Project	<b>IEEE 802.16 Broadband Wireless Access Working Group</b> < <a href="http://ieee802.org/16">http://ieee802.org/16</a> >	
Title	<b>Handover - Data Forwarding and deferring IP re-establishment</b>	
Date Submitted	<b>2004-06-07</b>	
Source(s)	Yong-Ho Kim LG Electronics, Inc. 533, Hogye-1dong, Dongan-gu, Anyang-shi, Kyongki-do, Korea	Voice: 82-31-450-4387 Fax: 82-31-450-7912 <a href="mailto:ronnykim@lge.com">mailto: ronnykim@lge.com</a>
Re:	Response to IEEE 802.16-04/19 (Recirculation Ballot #14a)	
Abstract	Handover - Data Forwarding and deferring IP re-establishment	
Purpose	Enhance the handover performance during handover	
Notice	This document has been prepared to assist IEEE 802.16. It is offered as a basis for discussion and is not binding on the contributing individual(s) or organization(s). The material in this document is subject to change in form and content after further study. The contributor(s) reserve(s) the right to add, amend or withdraw material contained herein.

# Data Forwarding and deferring IP re-establishment

Figure 1. Data forwarding vs IP address re-establishment

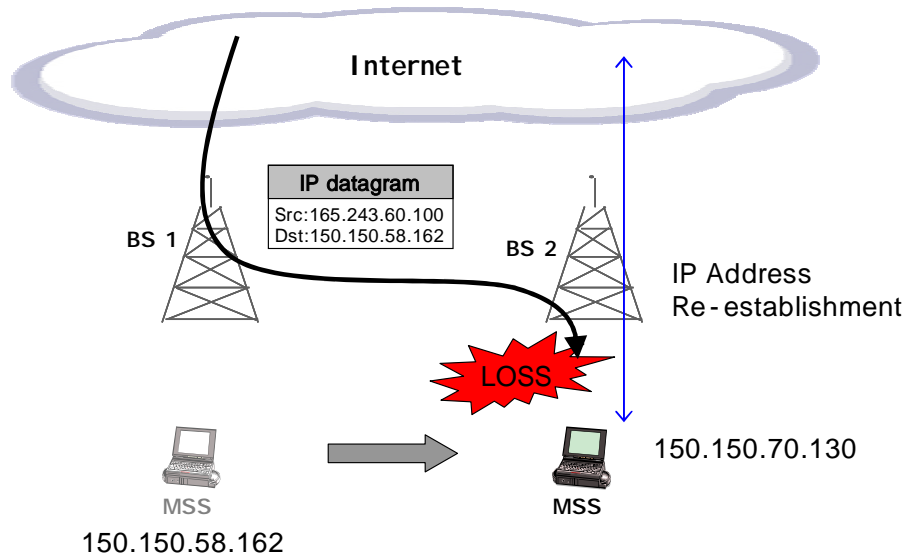
When handover is performed, the serving BS may either discard MAC SDUs associated with the MSS or forward MAC SDUs for service continuation. However in case of data forwarding, if the MSS re-establishes IP connectivity after handover, forwarded data are useless due to IP address change.

Therefore, it is required for MSS to defer IP re-establishment if there are forwarded data from the serving BS.

Figure 2. Data forwarding and deferring IP re-establishment

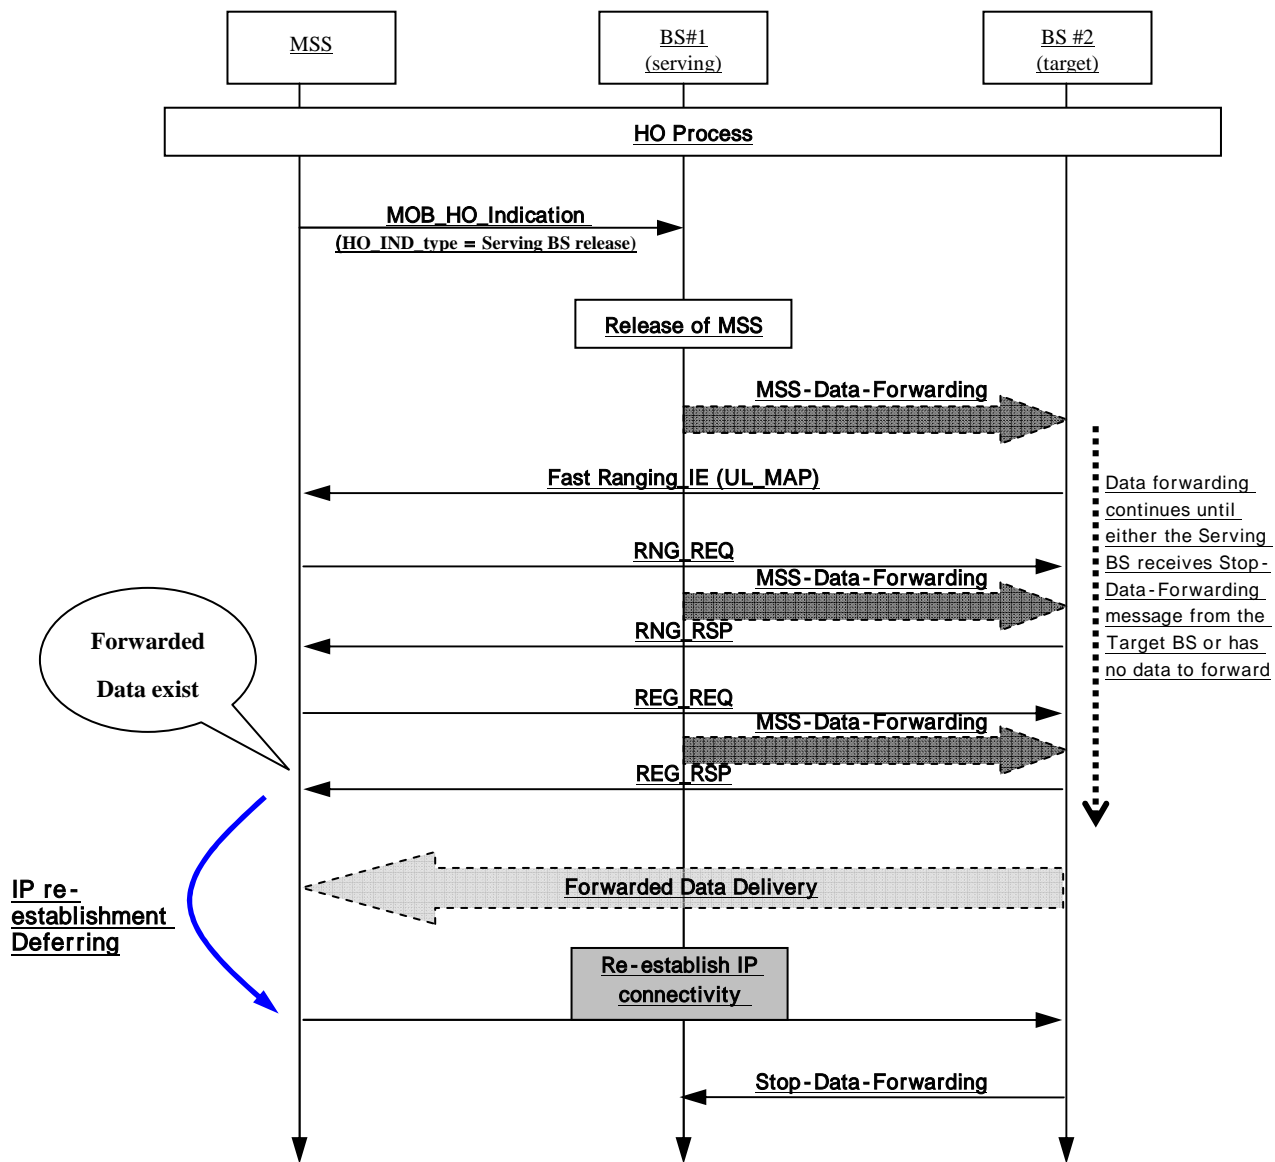
If the serving BS decides to forward data to the target BS for moving MSS's service continuation, the serving BS will forward data through backbone and the target BS will receive them. At this time, the target BS notices the MSS of data to receive after HO. The MSS will register with the target BS, and the target BS will notify the MSS of forwarded data existence in REG-RSP message. Now MSS can decide when IP re-establishment should be performed. The MSS may defer re-establishment of IP connectivity to receive data or may re-establish IP connectivity. During data is being forwarded to the target BS, if the MSS re-establishes IP connectivity then the target BS may send a backbone message (Stop-Data-Forwarding) to stop data forwarding to the serving BS. When the serving BS receives the Stop-Data-Forwarding, the BS may close all connections and discard state machines and MAC SDUs associated with the MSS.

Use one bit in *Method for allocating IP address* TLV of REG-RSP to indicate the MSS of forwarded data existence. Insert paragraph describing BS's and MSS's actions of data forwarding. Add backbone messages for data forwarding and stop data forwarding over a backbone.
